**METROPOLITAN GOVERNMENT OF NASHVILLE AND DAVIDSON COUNTY**

**STAFF RECOMMENDATION**

**1406 Holly Street**

**Description of Project:** Applicant proposes to demolish the non-contributing building currently located at 1406 Holly Street and construct a 1.5 story, single-family dwelling utilizing the existing garage.

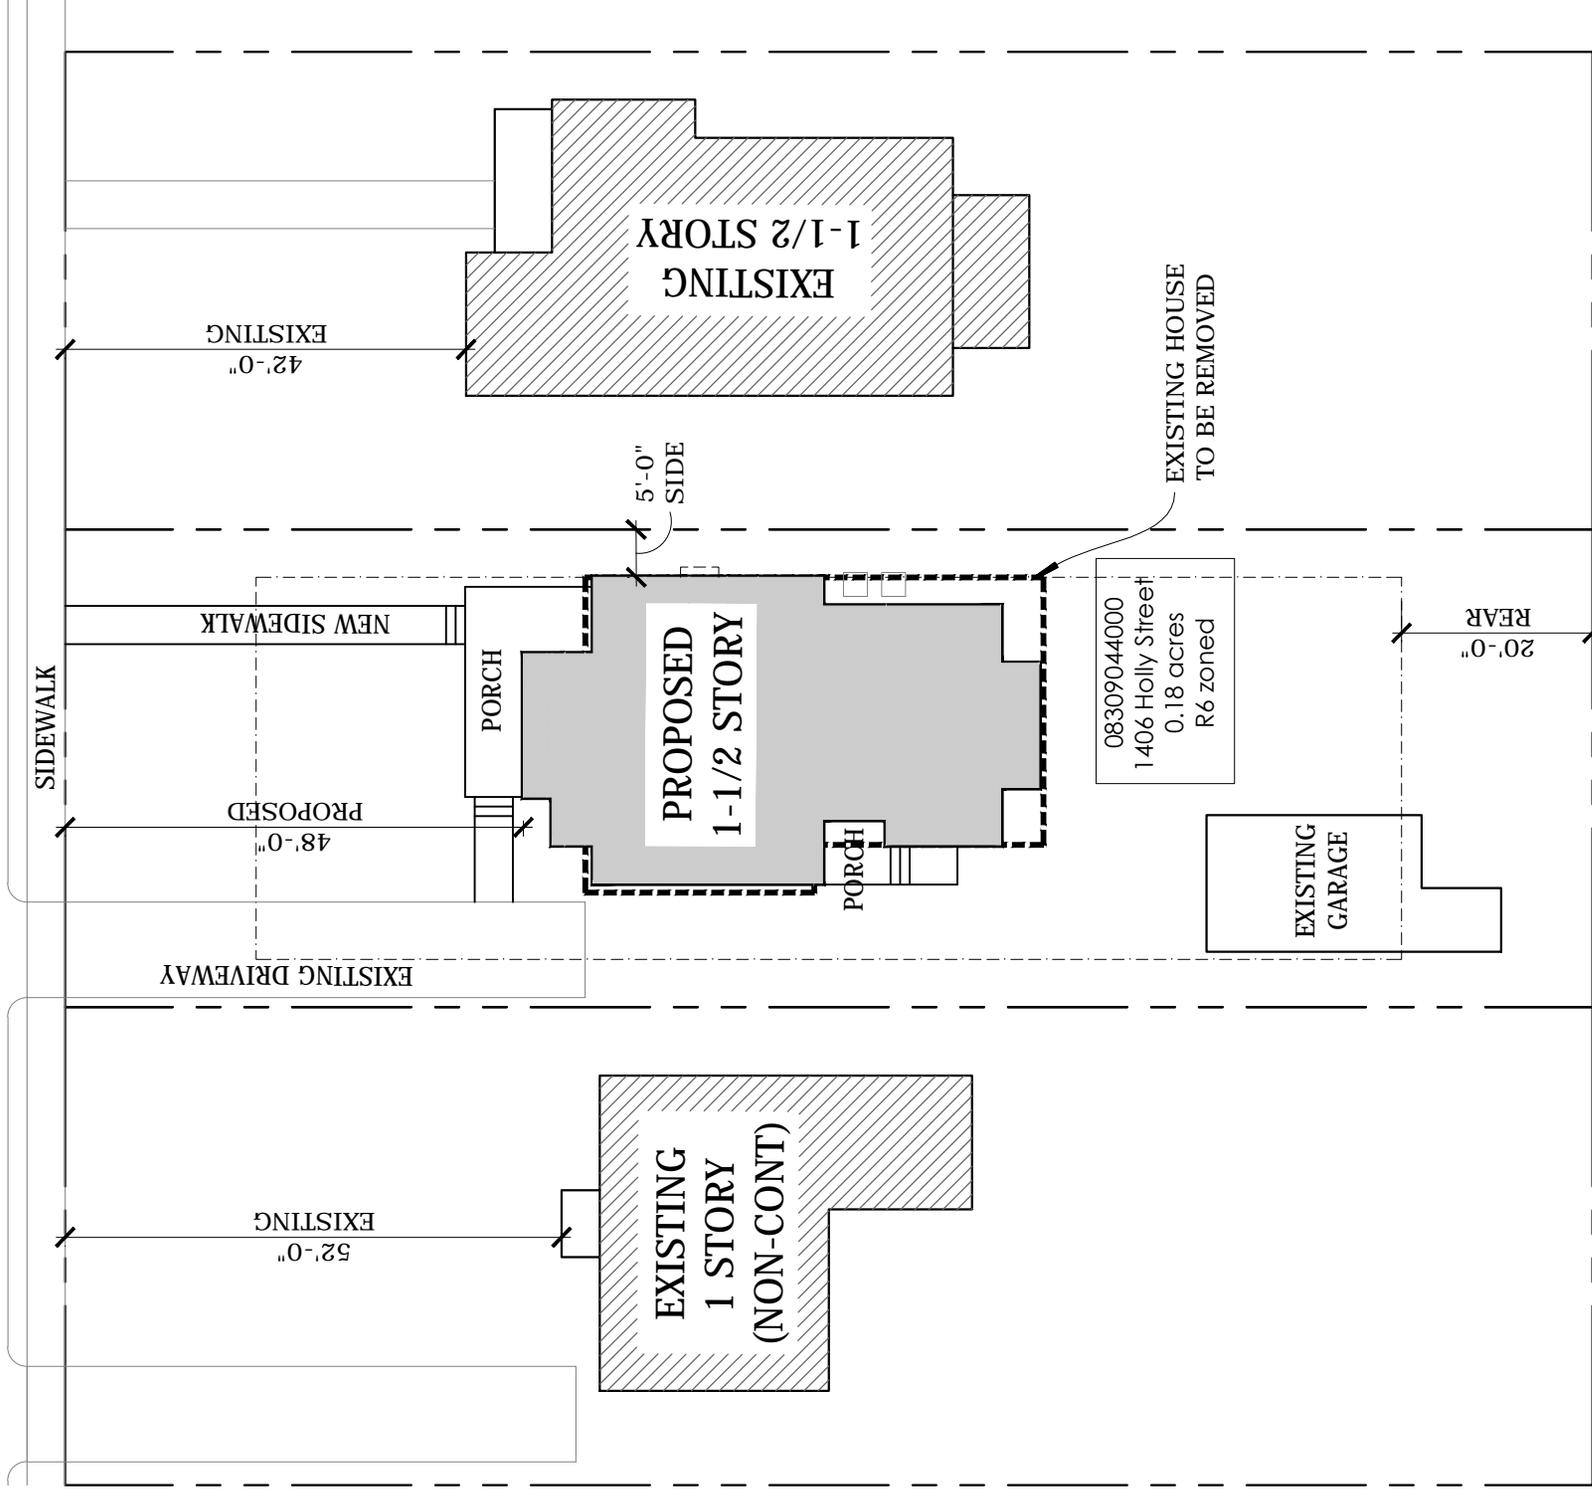
Context across the street from the proposed project.

Context cross the street from the proposed project

Context to the right of the project.

Context to the left of the proposed project

Additional context on the 1400 block of Holly Street.

EL1 FRONT ELEVATION

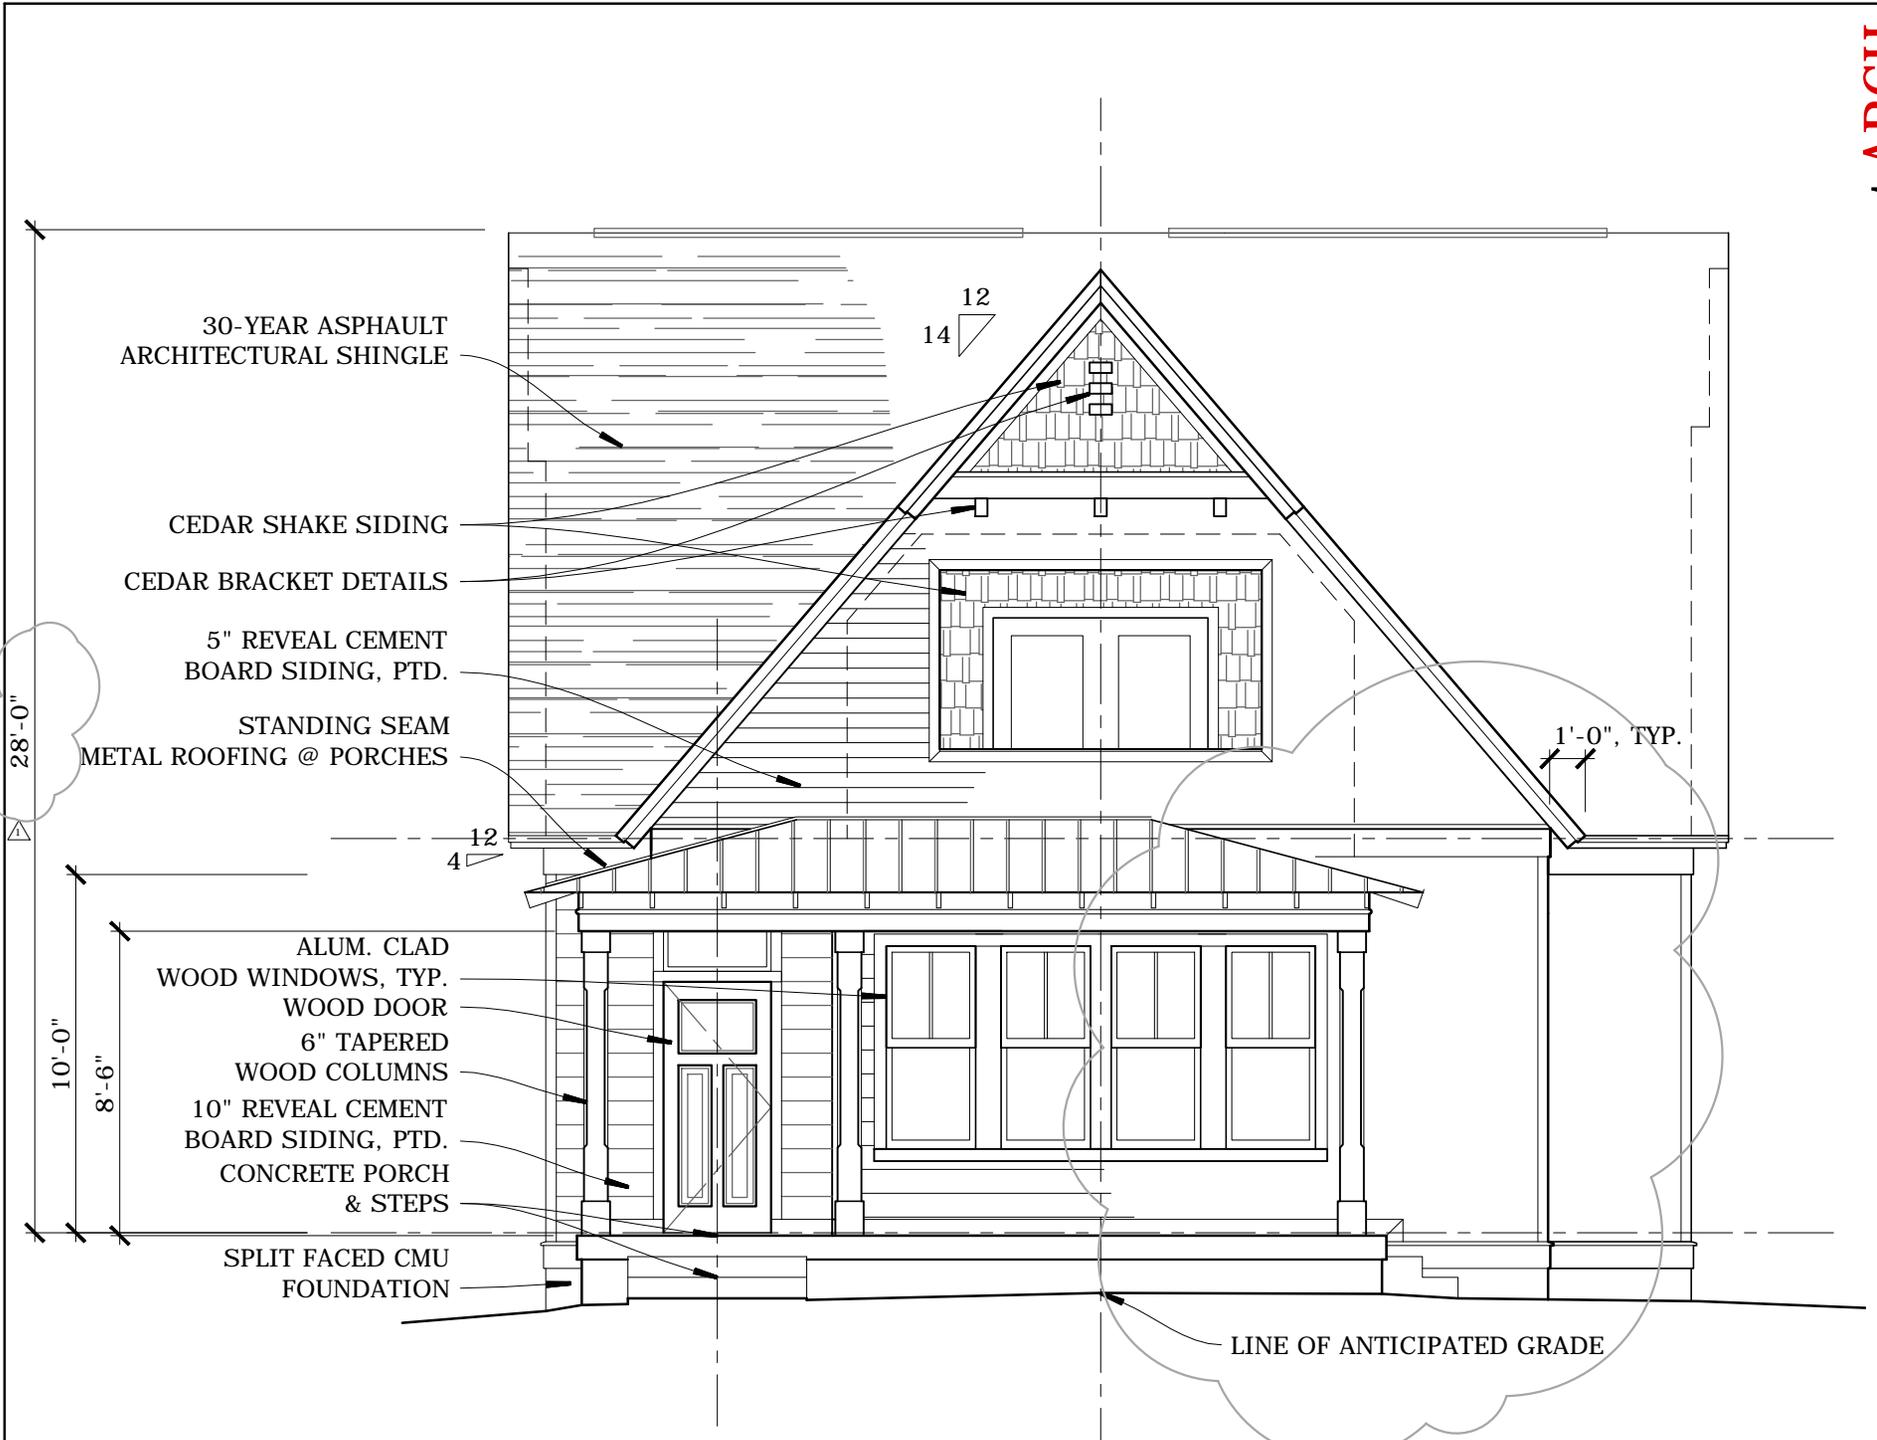
**Height & Scale:** The proposed house is one and one-half story home, as are the majority buildings in the immediate vicinity. The foundation height is approximately two feet (2') tall from the lowest grade point as seen from the front, which is in keeping with the historic buildings on either side.

The eave height is approximately eleven feet (11') from the foundation line and the ridge is approximately twenty-nine feet (29') from the foundation line or approximately thirty-one feet (31') from grade. The historic context along Holly Street varies greatly between seventeen and thirty-four feet (17'-34') tall from grade, with the closest homes being in the seventeen to twenty six foot (17'-26') range. The majority of Lockeland Springs-East End is very eclectic in style and massing, with homes ranging between one and three stories. There are a few areas where all the development happened at the same time with homes very consistent in massing and style. This area is of the more eclectic variety, so although the properties immediately around the lot have shorter homes than what is proposed; staff did not find the condition to be an unusual for this portion of the district. For instance, in the 1200 block of Holly Street there is an approximately twenty-one foot (21') tall house flanked by homes that are approximately thirty-two feet (32') tall from grade. Just behind this proposed project, in the 1400 block of Russell Street, there is an approximately sixteen foot (16') tall building next to a twenty-five foot tall house.

**Relationship of Materials, Textures, Details, and Material Colors:** The foundation shall be split faced CMU, the siding cement fiber lap siding with a mix of reveals of 10" on the first floor and 5" on the second level as well as cedar shake shingle. Typically the Commission has not allowed for lap siding reveals of more than five inches (5") but there have been instances where wider reveals have been approved when it is mixed with the more appropriate five inch (5") reveal, as proposed here. The roof is asphalt shingle in a graphite gray color. The floors of the porches are concrete, the posts milled wood, and the roof of the porches are standing seam metal, color unknown. The windows are Pella Proline, aluminum clad, two-over-one and one-over-one windows. The doors are Jeld-

**Roof Shape:** The roof form is a cross-gable with rear shed-roof dormers. The exterior side chimney does not penetrate the roof but truncates at the side vergeboard. The roof pitches are 14/12 which match historic roof pitches throughout the district. Staff finds the roof shape to be appropriate and meets section II.B.5 of the design guidelines.

**Orientation:** The building is oriented towards Holly Street with a primary entrance, porch and walkway leading to the sidewalk, as are other historic buildings in the district. The depth of the porch is six (6') which has been a minimum depth required by the Commission to result in a usable porch. The project meets section II.B.6.

**Proportion and Rhythm of Openings:** The windows are twice as tall as they are wide. There are no instances where there is more than eight foot (8') of linear wall space without a break with a window, door, or chimney. Paired windows have the minimum four inch (4") mullion required by the Commission on past projects. The project meets section II.B.7.
